October 24, 2016

Re: Response to Ecology's *Opinion Pursuant to WAC 173-340-515(5) on Remedial Action for the Following Hazardous Waste Site:*

Site Name: Lake Goodwin Store 2013
Address: 4726 Lakewood Road, Stanwood, WA 98292
Facility/Site No.: 12889948
Cleanup Site ID No.: 12352
VCP No.: NW2974

FIGURE 4a

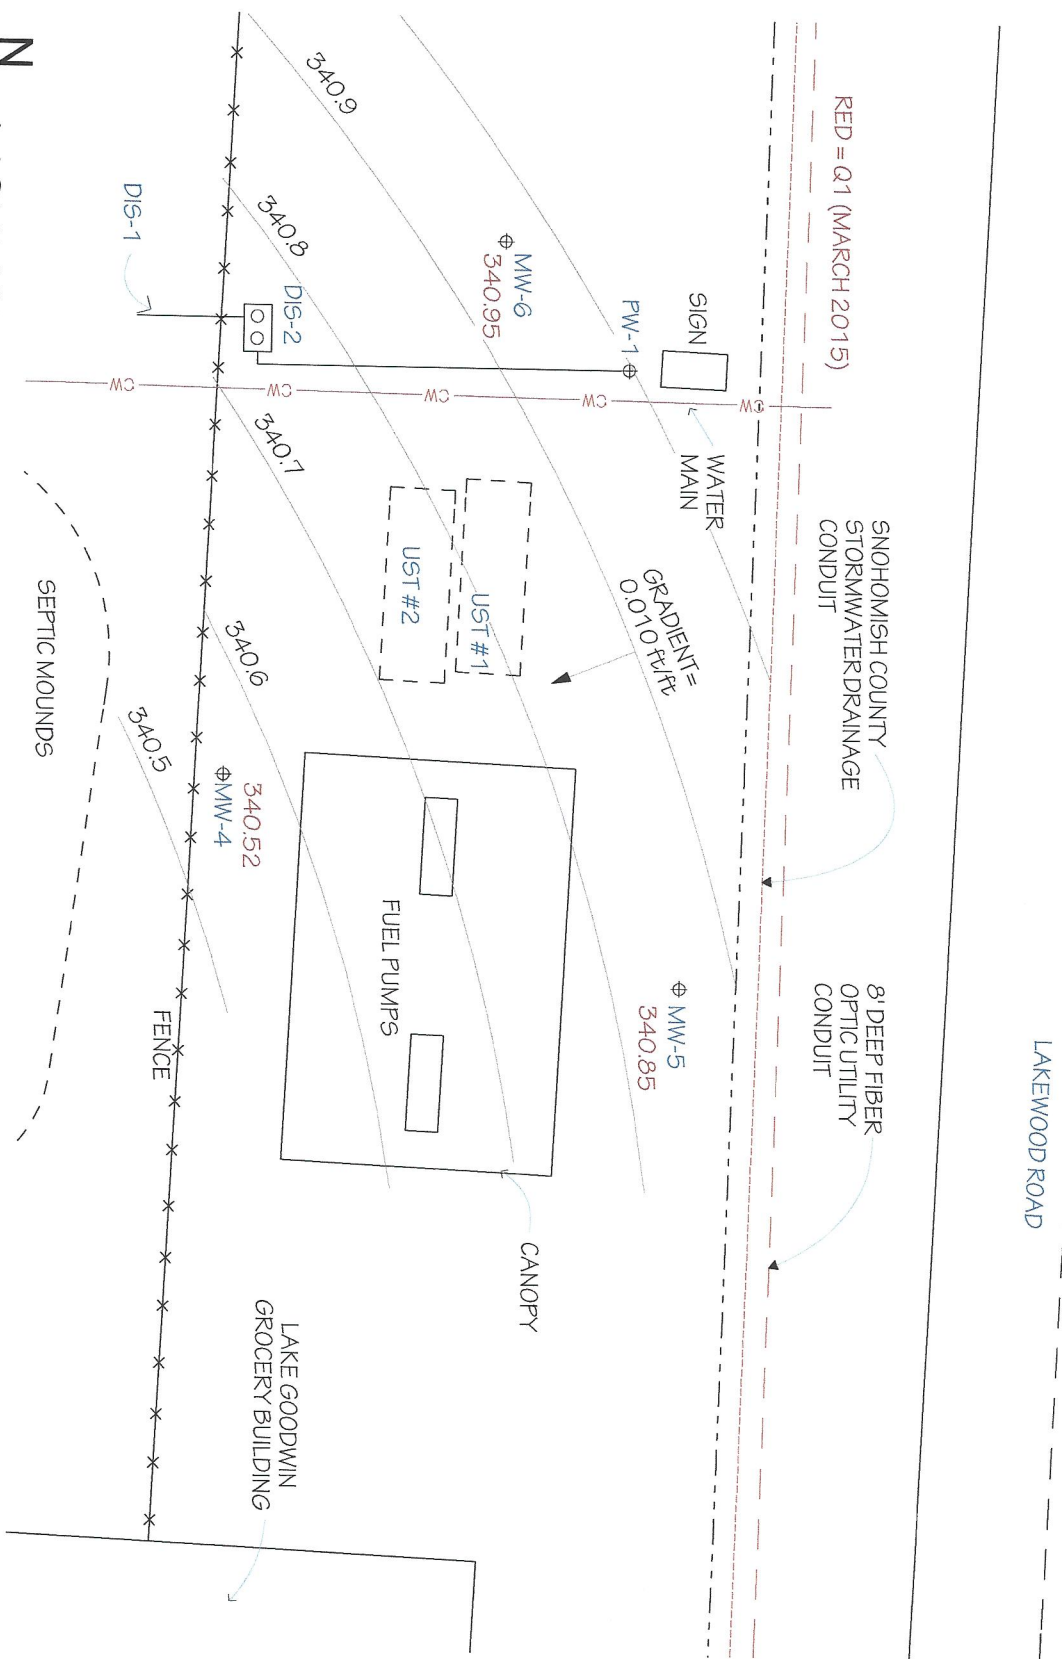
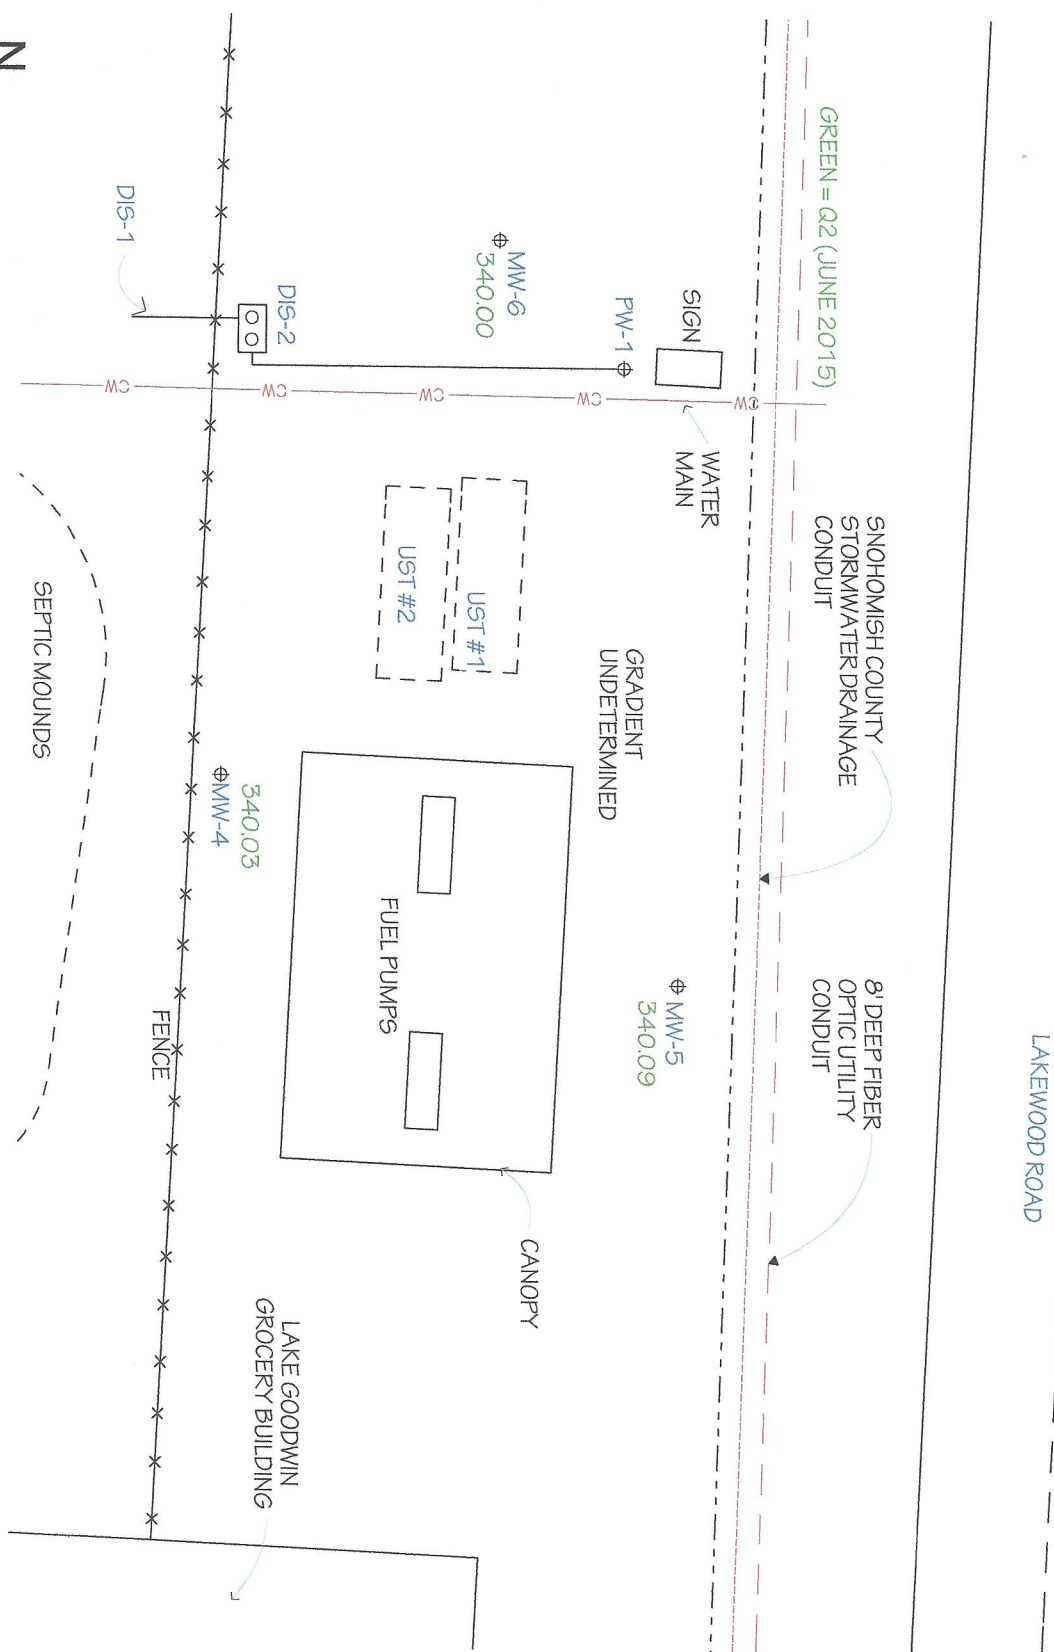
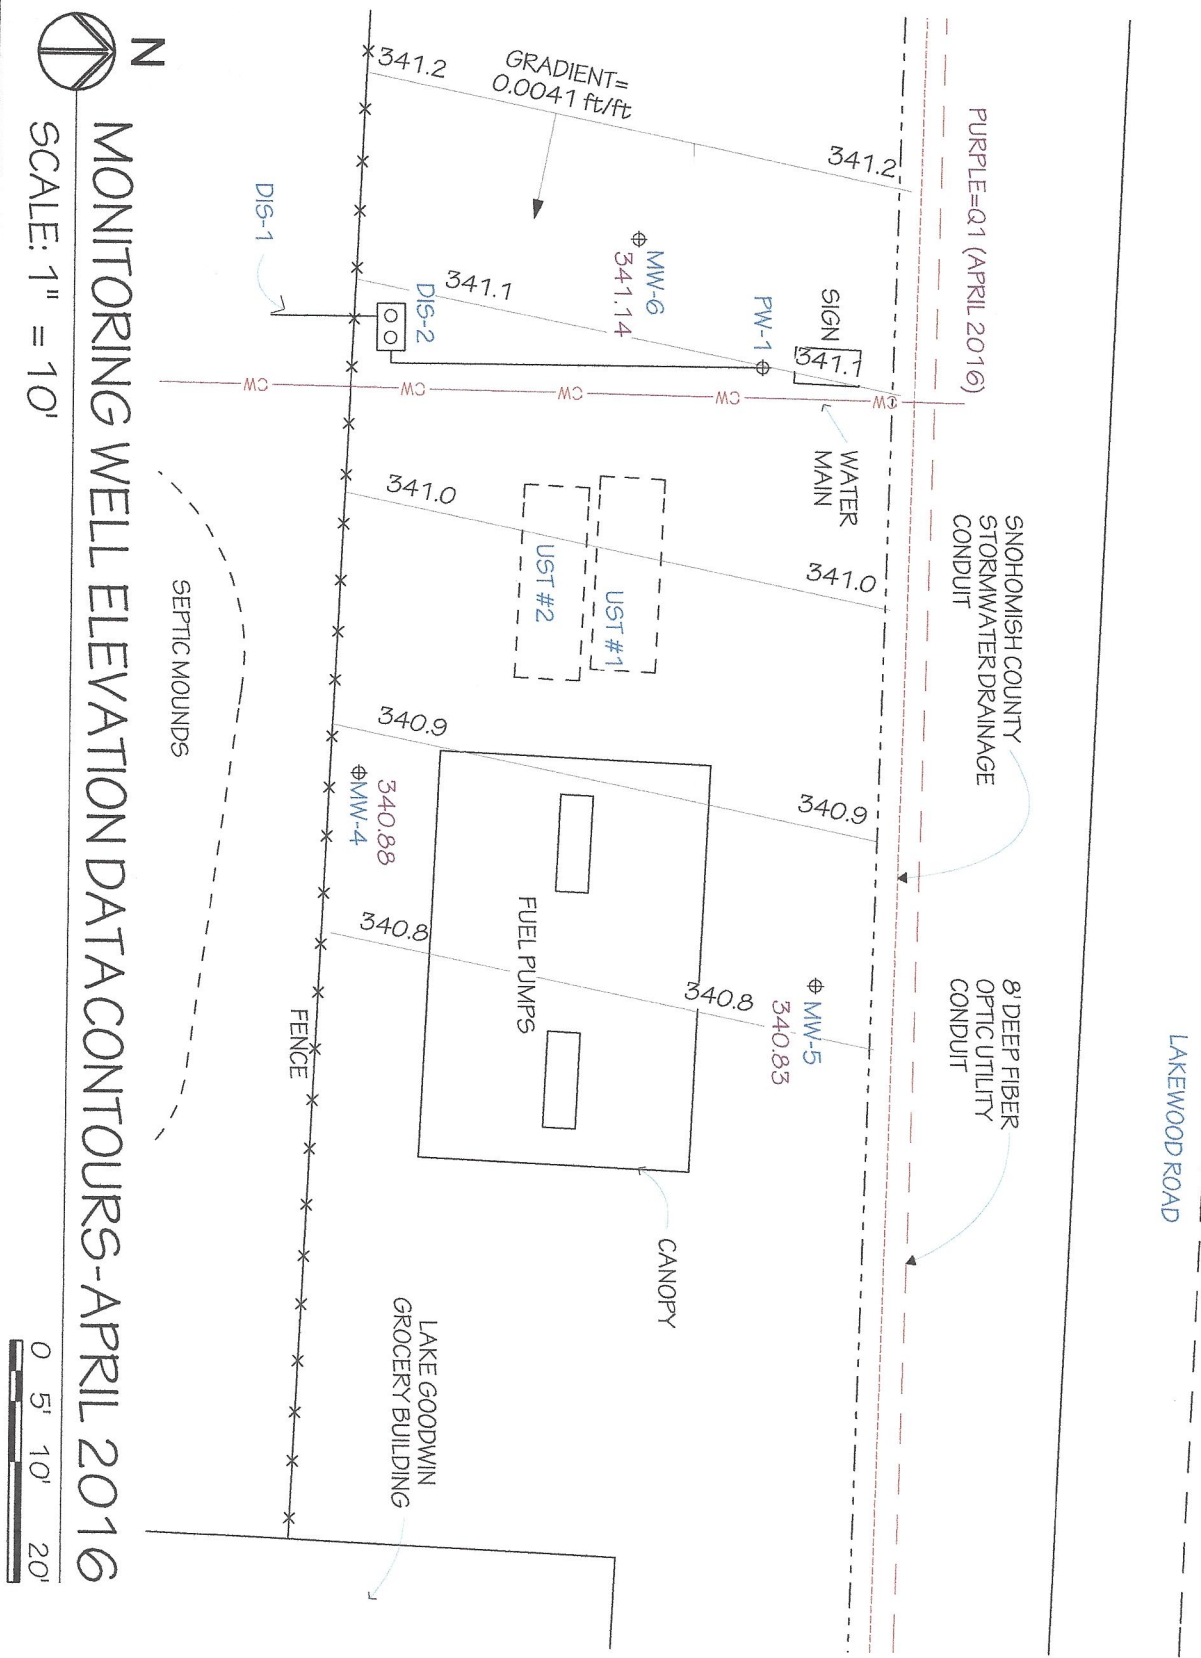
- *A Site conceptual model needs to be developed that shows how and where the TPH-g and BTEX release likely migrated after entering the subsurface. It is unlikely that TPH-g impacts to soil were limited to the upper one foot based on the ground water impacts identified in up gradient monitoring well MW-5 and cross gradient well MW-4. Based on the location of the release, estimated ground water flow direction and the location of PW-1, it is unclear how MW-5 was impacted by this release.*

- *A ground water elevation contour map needs to be provided for each quarterly monitoring event.*

Additional data and analysis are presented in this letter that address the CSM elements necessary to respond to Ecology's comment. In response to the above comment, however, SD&C has prepared Site map/drainage plan (Figure 1) that illustrates the numerous influences on the shallow groundwater flow at the Site. The shallow groundwater in the spill area is influenced by the Snohomish County storm water drainage utility, 8 ft. deep optical fiber vault, the PW-1 pumping well, and mounding from the RV site septic field. SD&C has also tabulated the results of groundwater monitoring data collected from the wells since May 13, 2014 and prepared figures (Figures 3a,b,c/2014, and Figures 4a,b,c,d/2015 and Figure 4e/2016) that illustrate the change of direction in shallow groundwater.

The quarterly water level elevation data is summarized on the attached Figures 3a,b,c/2014, Figures 4a,b,c,d/2015, 4e/2016.

Figure 8

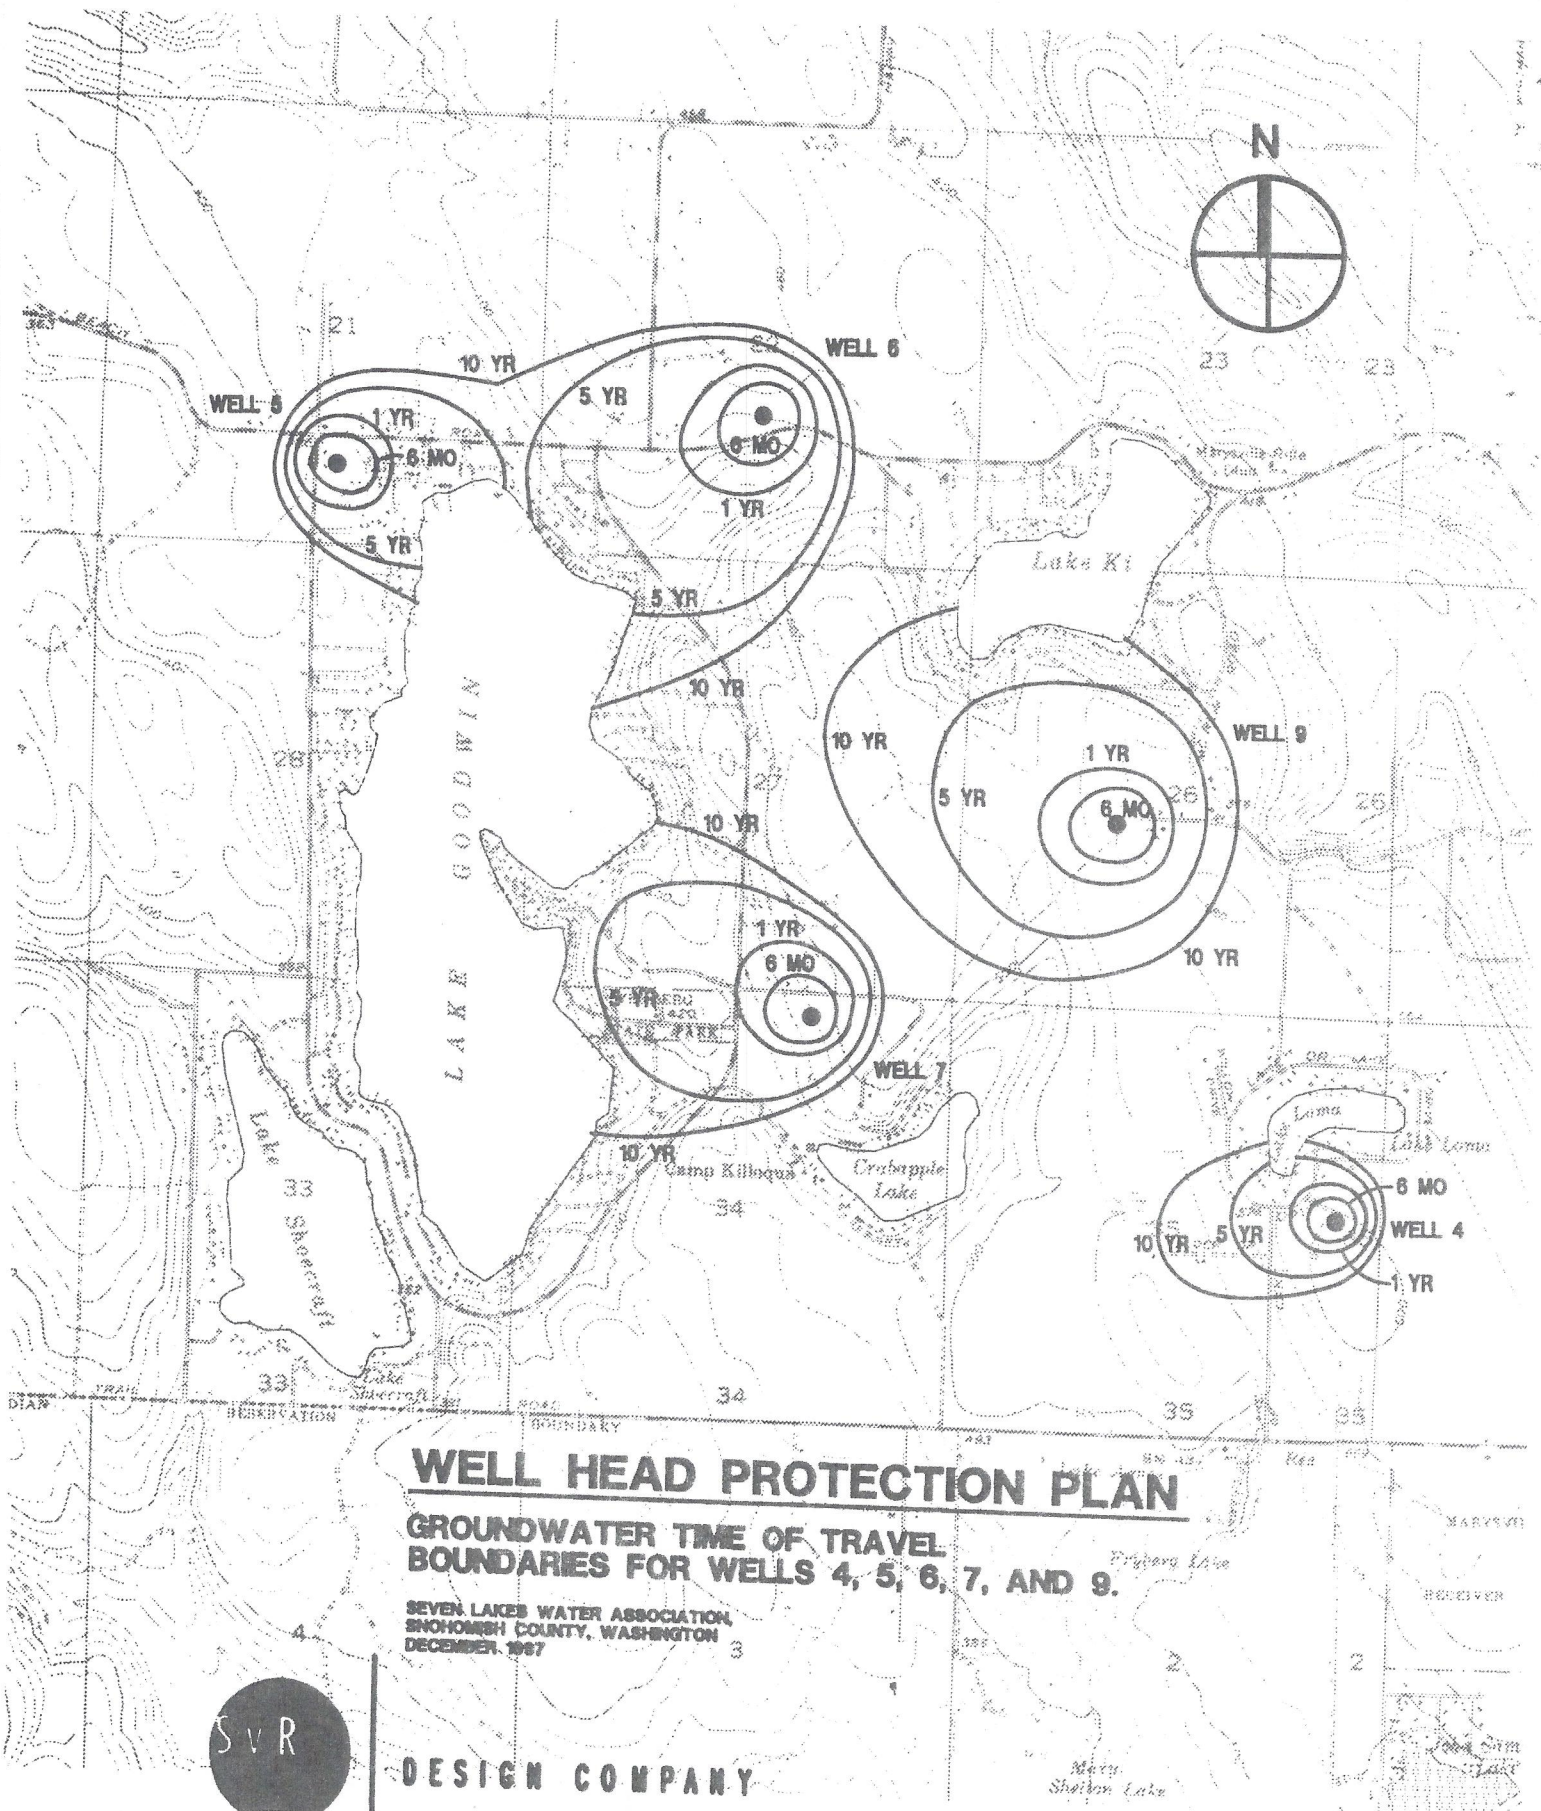
- *The number of municipal and domestic water supply wells in the vicinity of the Property, current use, distance from the Site, depth to water, production rate, screened interval depth and any available water quality data should be submitted. A map (with scale) illustrating the location of nearby wells relative to the Site should also be provided.*

Mr. Lucas provided Figure 8, attached to this letter, from the Seven Lakes Water Association Well Head Protection Plan. This diagram identifies estimated groundwater travel times to water wells in the vicinity of the Site. The well logs indicate that Well #5 is the closest municipal supply well to the Site. Mr. Lucas advised SD&C that this well is not in use and is planned for decommissioning. The logs indicate Well #5 is screened at 170 ft. bgs, and although upgradient, it would not have a hydraulic connection with the Site.
